SUBJECT: Forwards response to NRC 820311 request for addl info re low temp overpressure protection.

Duke Power Company
Oconee Nuclear Station

Response to NRC Request for Additional Information
Low Temperature Overpressure Protection

Figure 1

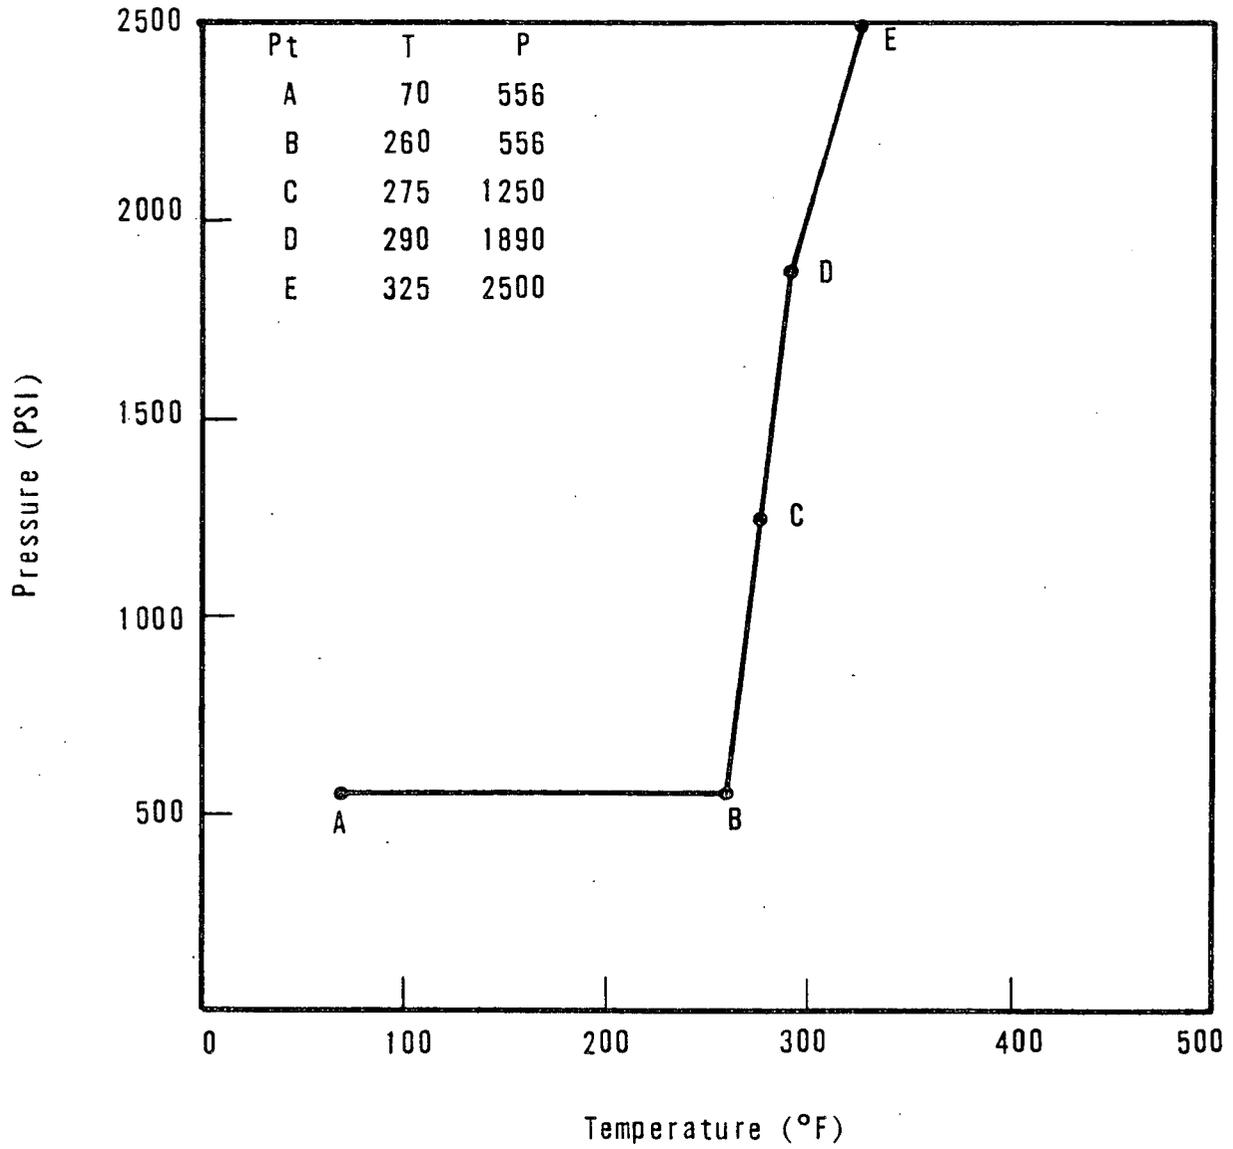
A more appropriate P-T limit curve for the low temperature overpressure protection issue has been calculated and is shown in Figure 1. This curve was calculated using the limiting Oconee reactor vessel and the assumed heatup and cooldown rates in Table 1. The curve is a composite formed by combining the most limiting portions (lowest pressure, greatest temperature) of three constituent curves: (1) A P-T limit curve for normal plant heatup; (2) a P-T limit curve for normal plant cooldown; and (3) a P-T limit curve for hydrotest and inservice leak test. With one exception, the development of these constituent curves follows the method used to obtain Technical Specification curves in accordance with Appendix G of the Code. However, instead of safety factors of 2.0 and 1.5, development of the constituent curves for Figure 1 assumed a safety factor of 1.0.

5. RSB 5-2 requires that an alarm must be provided to alert the operator that a pressure transient is occurring. You take credit for operator action to mitigate a pressure transient for all analyzed events when a failed-closed PORV is considered. No credit can be taken for operator action until 10 minutes after the operator is aware that a pressure transient is in progress. For the most severe event that you analyzed, what audible alarm will alert the operators that a pressure transient is occurring (alarms associated with the PORV cannot be used because it is assumed failed closed)? We require that acceptable technical specification changes or system modifications be proposed to increase your calculated operator time from 4.4 minutes to at least 10 minutes.

in a reduction of the minimum pressurization temperature to 325°F at 15 EFPY. This is well below the current value of 408°F at 6 EFPY which is based on safety factors of 2.0 and 1.5 and assumes much greater heatup and cooldown rates (100°F/hr.).

The postulated severe event is considered to be spurious opening of HP-26. This can only be postulated to occur at RC temperature conditions above 325°F. The operator has several indications that a pressurization transient is in progress. These include:

1. HP-26 not closed;
2. Pressurizer level high alarm (260");
3. HP flow in excess of normal 40-80 gpm
(An actual alarm would occur if flow was in excess of 500 gpm.);
4. RC pressure increasing (Alarmed at 2255 psig).

As can be seen with Figure 1, full system pressure is allowed for fluid temperatures above 325°F.
